AGENDA BIRMINGHAM DESIGN REVIEW BOARD Wednesday - November 16, 2022 BIRMINGHAM CITY HALL, 151 MARTIN ST, COMMISSION ROOM 205, BIRMINGHAM MI *

MEMORANDUM

SUBJECT: 34040 Woodward – Community Unity Bank – Design Review

A-500
EXTERIOR SIGNAGE

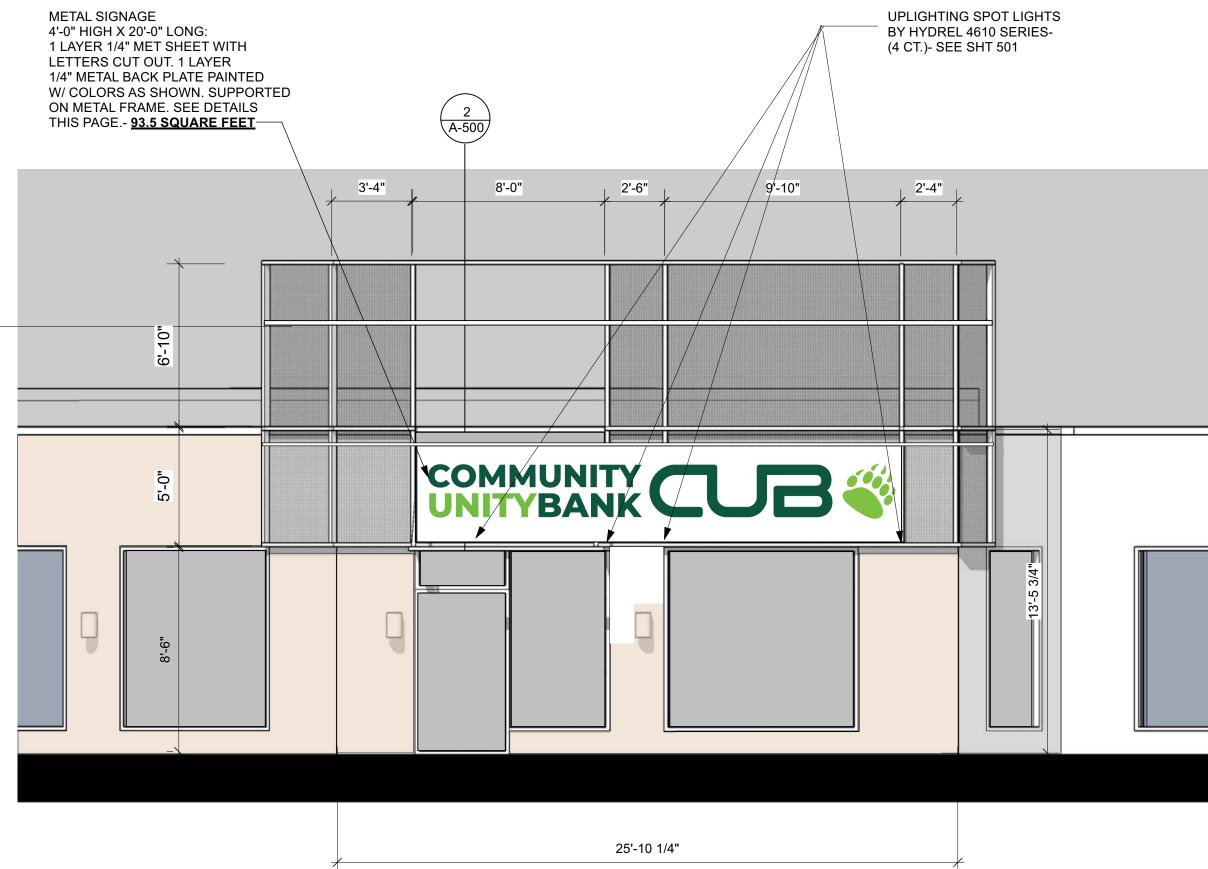
There is one new sign proposed as a part of the Design Review submitted. The sign is proposed as a metal wall sign to be mounted on the steel mesh and metal frame structure. The sign itself is made out of a layer ¼" metal sheet with letters cut out and a layer of ¼" metal back plate painted with colors as shown on the plans provided.

The total area of the proposed sign is 80 sq. ft. and the sign is proposed to be mounted in the sign band. The total linear building frontage for this tenant is 53.5 ft. on Woodward, which means that the total allowable combined sign area for this tenant is 80.25 sq. ft. It is worth noting that the plans are inconsistent in some areas after revisions, which will need to be updated.

The proposed Hydrel spotlight light fixtures are not full cutoff as defined in Section 9.02. Thus, the Design Review Board should discuss the proposed fixtures in regards to the six conditions listed above and determine if an exception will be granted.

Finally, it is unclear as to whether or not the existing light fixtures located on the façade will remain, be removed, or be relocated. **The applicant must clarify what will become of the existing light fixtures.**

- 1. The applicant must submit revised plans with consistent signage details;
- 2. The Design Review Board APPROVES the non-cutoff light fixtures pursuant to Article 4, Section 4.21 (D) of the Zoning Ordinance;
